Access Compliance Report Public Rights-of-Way (Curb Ramps)

Main Street: HEWES_ST Cross Street: E_JULIE_AVE Location: NE

ADA ID: RPRK211222135101 Ramp Type: Type 4 - Parallel Initial Pass/Fail: Pass Overall Compliance: No Severity Score: 10

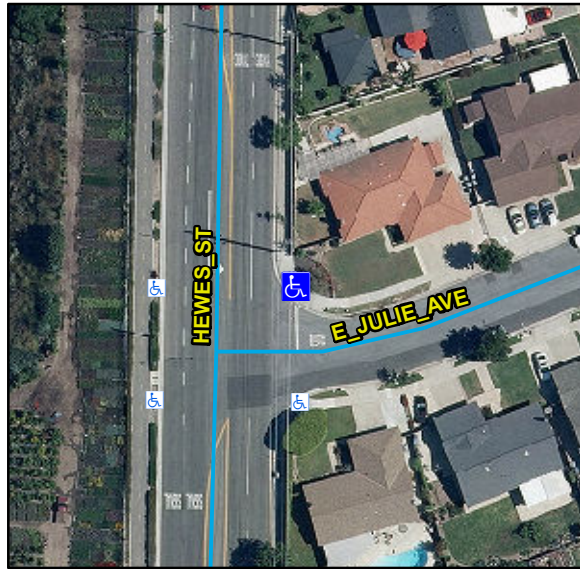
Compliance	Description	Data	Compliance	Description	Data
N/A	Ramp Length LT (in)	101	N/A	Ramp Length RT (in)	101
Yes	Ramp Width LT (in)	83	Yes	Ramp Width RT (in)	83
Yes	Ramp Run Slope LT (%)	7.1	Yes	Ramp Run Slope RT (%)	6.7
Yes	Ramp Cross Slope LT (%)	0.8	Yes	Ramp Cross Slope RT (%)	1.1
N/A	Landing Present	Yes	Yes	DWS Provided	Yes
N/A	Landing Length (in)	83	Yes	DWS Contrast	Yes
Yes	Landing Width (in)	48	Yes	DWS Length (in)	36
No	Landing Run Slope (%)	2.5	No	DWS Full Width	No
Yes	Landing Cross Slope (%)	0.1		DWS Offset Type	Single
N/A	Landing Movement Obstructed?	No	Yes	DWS Offset Left (in)	0
	Landing Movement Type	Curb	Yes	DWS Offset Right (in)	N/A
N/A	Landing Shared	No			
N/A	Clear Space	Yes			
N/A	Clear Space To Crosswalk (in)	48			
N/A	Marked Crosswalk 1	No	N/A	Marked Crosswalk 2	No
	Crossing 1 Direction	W		Crossing 2 Direction	S
	Marked Crosswalk 1 Width (in)	N/A		Marked Crosswalk 2 Width (in)	N/A
N/A	Ramp Inside Crosswalk 1	N/A	N/A	Ramp Inside Crosswalk 2	N/A

Crossing 1 Slope (%)	0.8		Crossing 2 Slope (%)	1.1
	Crossing 1 Cross Slope (%)	2.1		Crossing 2 Cross Slope (%)	0.9
Yes	Gutter Ponding	No	Yes	Curb Slope	3.5
Yes	Gutter Lip Height (in)	0		Road Run Slope (%)	0.6
No	Gutter Run Slope (%)	9.7		Road Cross Slope (%)	0.2
Yes	Gutter Cross Slope (%)	0.7	Yes	Perpendicular Joint Present	Yes
Yes	Overall Surface Condition	Acceptable			
	Cross Gutter Present?	No		Spandrel Present?	No
	Replace Cross Gutter?	N/A		Replace Spandrel?	N/A

Remove & Replace Curb Ramp With Two New Directional Ramps or Equivalent. Remove & Replace Gutter.
